# DA ACCESS ASSESSMENT REPORT

## *Selleys Warehouse & Laboratory*

Project Number: 119445

Revision: 2

#### 3.1 D3D22 – HANDRAILS

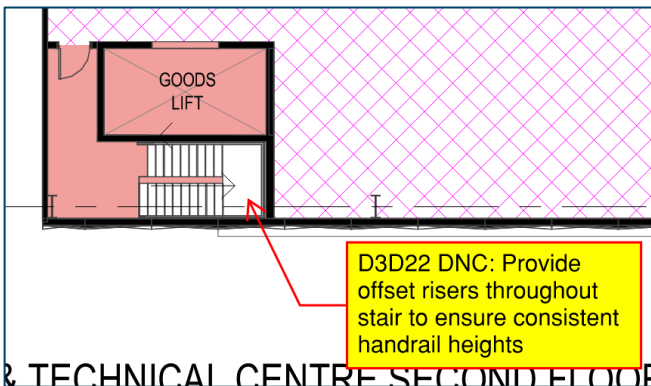
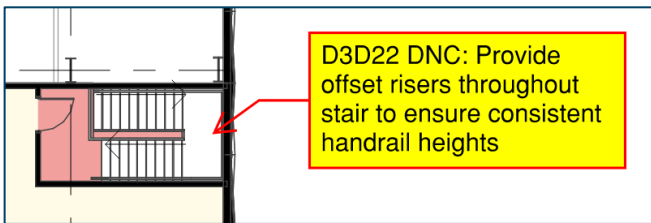
Throughout the stairways it is required that handrails are provided in accordance with this clause. To comply with Clause 12 of AS1428.1-2009 it is required to provide an offset to allow for a continuous height being maintained throughout the flights and landing.

The non-fire-isolated stairway to the office is required to be provided with handrails on both sides of the stair. Each fire-isolated stair in the office is required to be provided with offset risers throughout the stairway to ensure consistent handrail heights.

Ground Floor:

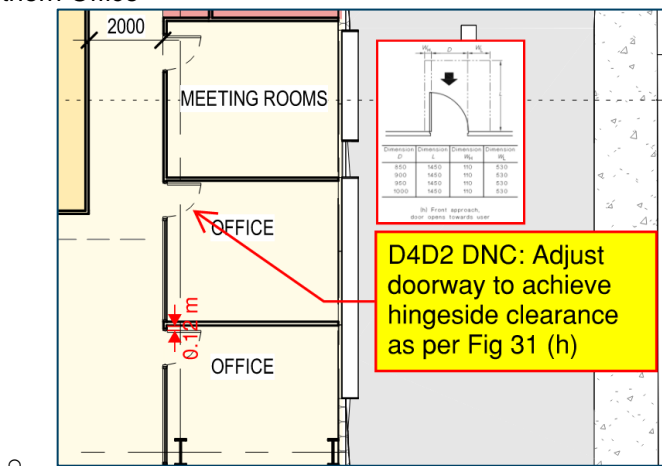
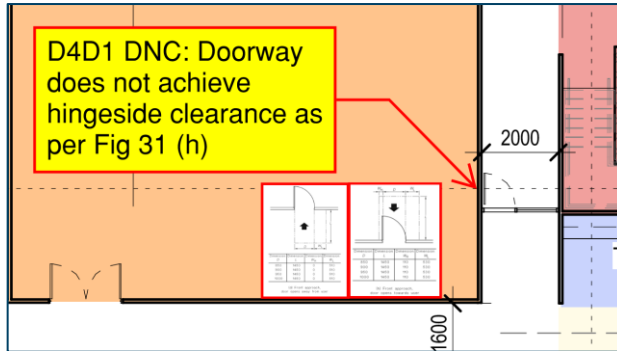
The following doorways are required to be updated to achieve the required doorway circulation clearances in accordance with AS1428.1-2009:

- Northern Office

- Central Corridor

First Floor:

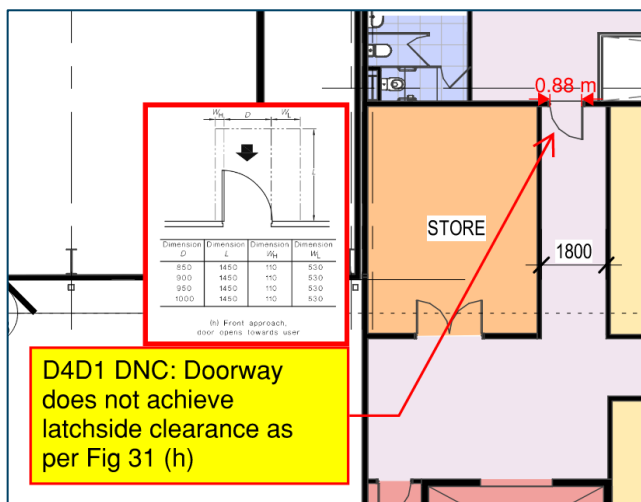
- Southern Corridor

### 3.3 D4D3 - ACCESS TO BUILDINGS

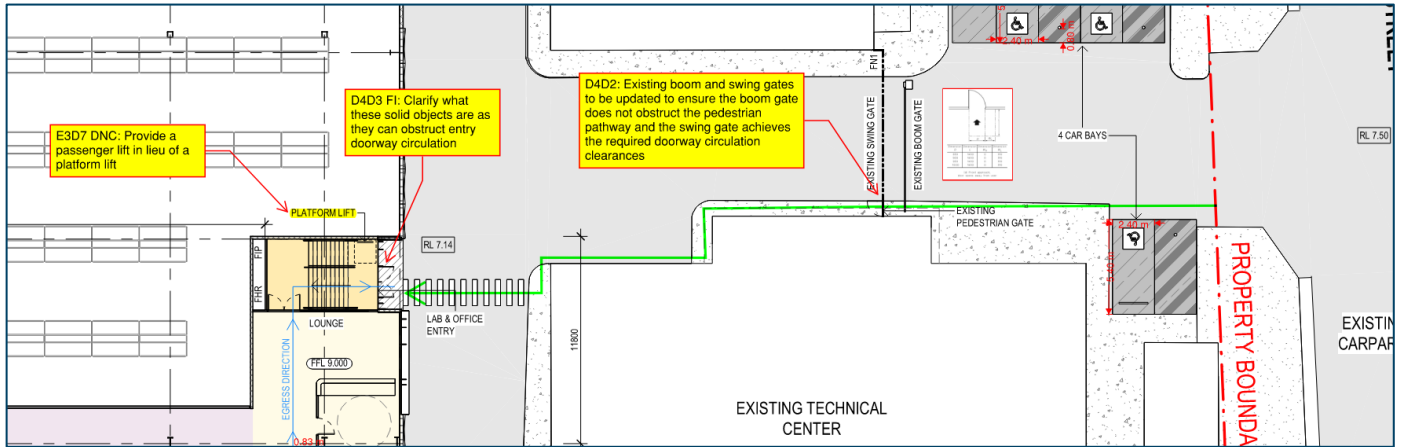
Access to the principal pedestrian entrance of the building is provided from Gow Street.

The following upgrades are required:

- Provide a continuous accessible path of travel from the property boundary to the office / lab entry
- Shorten the boom gate to not obstruct the pedestrian path of travel
- Upgrade the pedestrian swing gate to achieve doorway circulation clearance for a front on approach
- Clarify the solid building elements adjacent the entry doorway as these could obstruct doorway circulation clearance.
- Provide a passenger lift in lieu of a platform lift to access Ground Floor.

### 3.4 D4D4 - PARTS OF BUILDINGS TO BE ACCESSIBLE

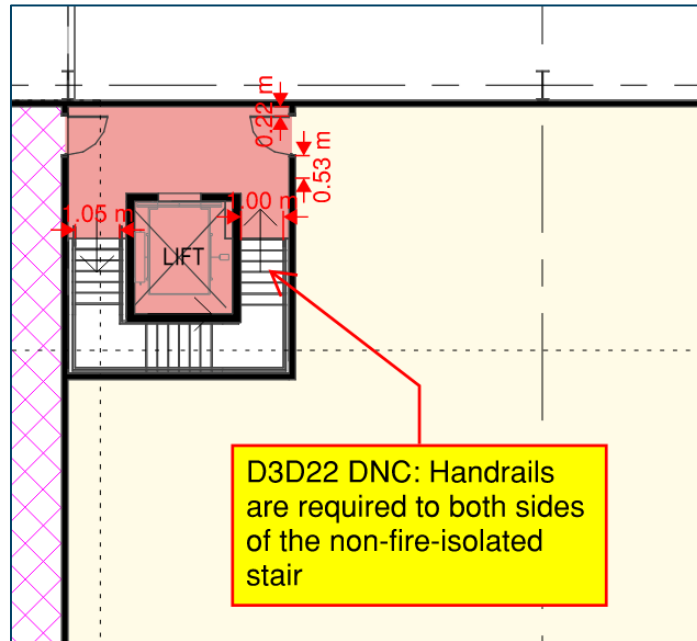
It is noted that the non-fire isolated stairway requires handrails on both sides of the stair, whereas only a single handrail has been provided. Plans will need to be updated accordingly.

### 3.5 E3D7 - PASSENGER LIFTS AND THEIR LIMITATIONS

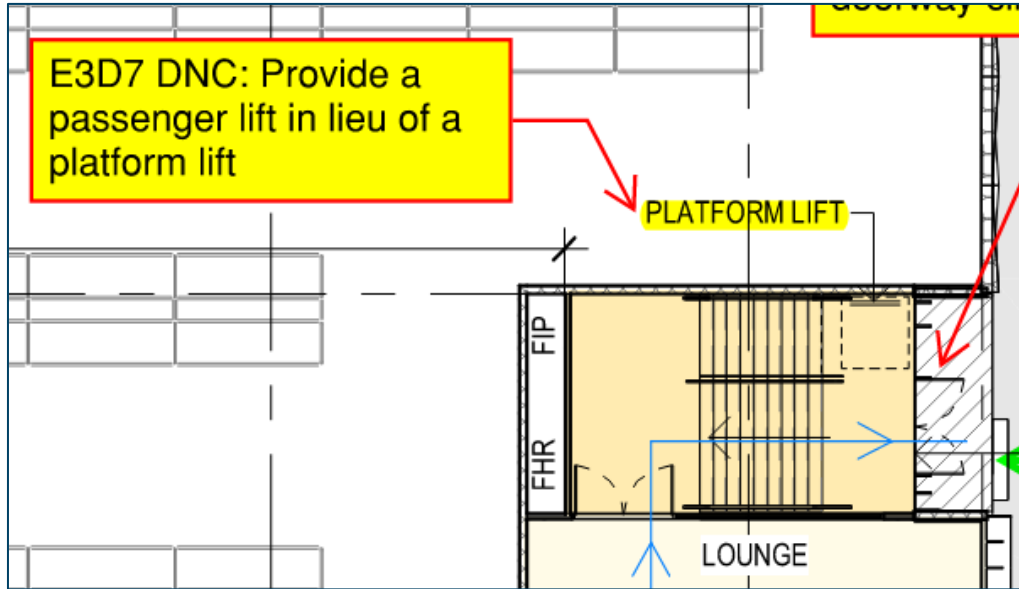
A stairway platform lift is proposed at the building entry which would not comply with the provisions of this clause as the building serves more than 100 persons.

It is required that a passenger lift is provided.

### 3.6 F4D6 - ACCESSIBLE UNISEX SANITARY COMPARTMENTS

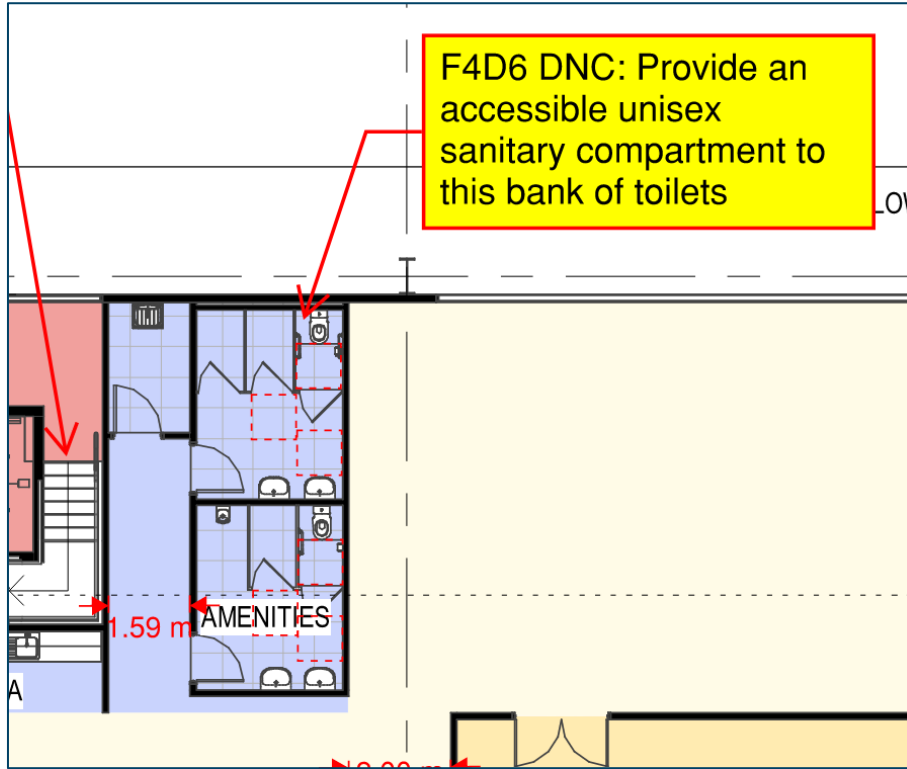
Accessible Unisex Sanitary Compartments are required at each bank of toilets.

They have not been provided at the central bank of toilets on Ground Floor & Level 1 and will be required.
